Subject: Follow-on submission by **John Hayes, 1 Seaview Avenue, Wexford, Co. Wexford** and others.

Re: Proposed development at Trinity Wharf, Trinity Street, Wexford, Co. Wexford – Case Reference PL26.303726

Image 1 Parking signage at Crescent Quay Off Street Car Park North, November 2019

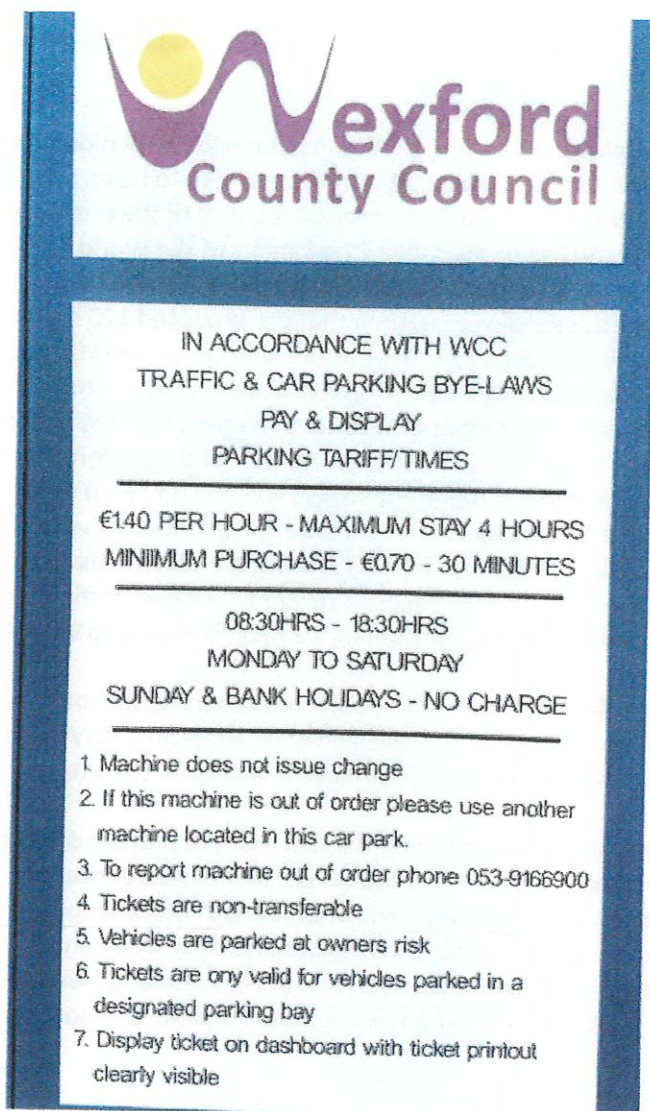
However, on further examining the parking figures provided it appears that Wexford County Council has inexplicably included the Crescent Quay Off Street Car Park North⁸, with a capacity of 61 car park spaces. In the initial application this was correctly identified as being unsuitable for workers on the proposed site as there is a parking restriction of 4 hours in place (Image 1).

This further reduces the theoretical available number of spaces within a ten-minute walk to 74 – significantly less than the number of spaces needed to support the office jobs only. Additionally, that number of 74 has been reduced further by the removal of on street long term parking at Paul Quay⁹ in November 2019 - removing approximately 13¹⁰ actual parking spaces that will have to be accommodated in the existing capacity and therefore reducing the theoretical figure

Image 12 Roadworks on William Street Upper during the traffic survey between Thursday, 5th to Thursday, 12th September

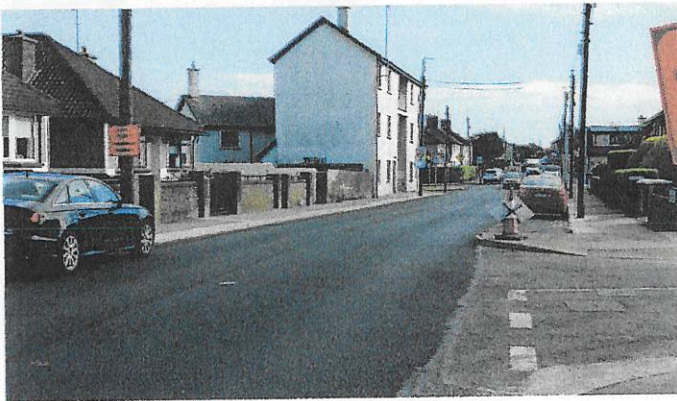
- a. The revised traffic survey carried out between Thursday, 5th to Thursday, 12th September 2019 (Appendix B1, Further Information Request – Wexford County Council Response), was completed at the same time as major road works were carried out along the entire length of William Street (Images 9-11). Traffic that diverted to avoid the roadworks was not measured as there were no surveys carried out on traffic flows in the Faythe or on Lambert Place (the main alternative route used by drivers). As such the traffic survey data does not reflect normal usage and should be discounted.

- b. Traffic junction counts at Fishers Row/ Trinity Street and Parnell Street/ Trinity Street are compromised by the same traffic works. For example, the number of turns from the Fishers Row into William Street seems to be very low, but can be easily explained when taking into account road works at the junction, as shown in Images 11 and 12.
